COMMUNITY BOARD FEEDBACK PACKAGE

Business Name: KOCHI

Cafe Address: 652 10TH AVE, NEW YORK, NY, 10036

Application Number: 20240618010007

46th St Frontage

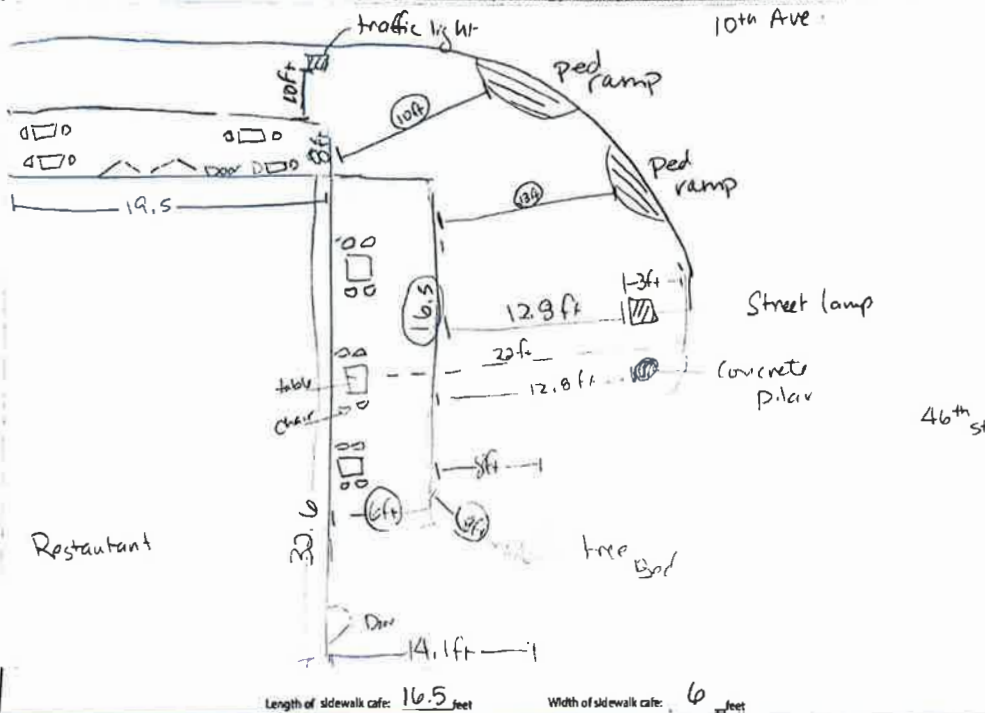
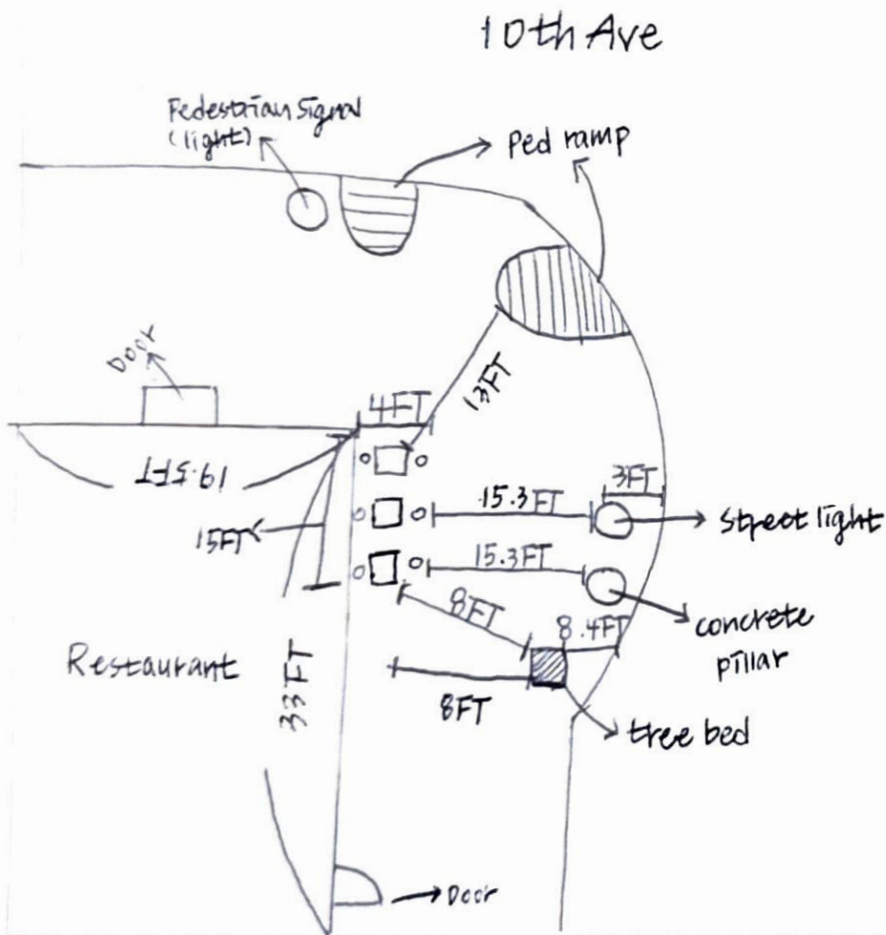
Comments related to the cafe's physical footprint and dimensions:
On the West 46th Street side of the cafe, the proposed Site Plan does not provide for the required 8 foot pedestrian clear path between the cafe perimeter and the street tree bed. To provide for the required clear path, the applicant has agreed to reduce the West 46th Street cafe to 3 tables with 2 seats each and has provided the attached Revised Site Plan.

☒ Community Board recommends **approval w/ modifications**
Recommended modifications (only if approved w/ modifications):
To provide for the required 8 foot pedestrian clear path, MCB4 requests modifications to the layout of the West 46th Street cafe. Applicant has agreed to these modifications, has reduced this side of the cafe to 3 tables with 2 seats each, and has provided the attached Revised Site Plan. MCB4's recommendation of approval is conditioned on this modification AND on applicant's permanently removing all canvas walls enclosing the cafe, which are not permitted for open air cafes.
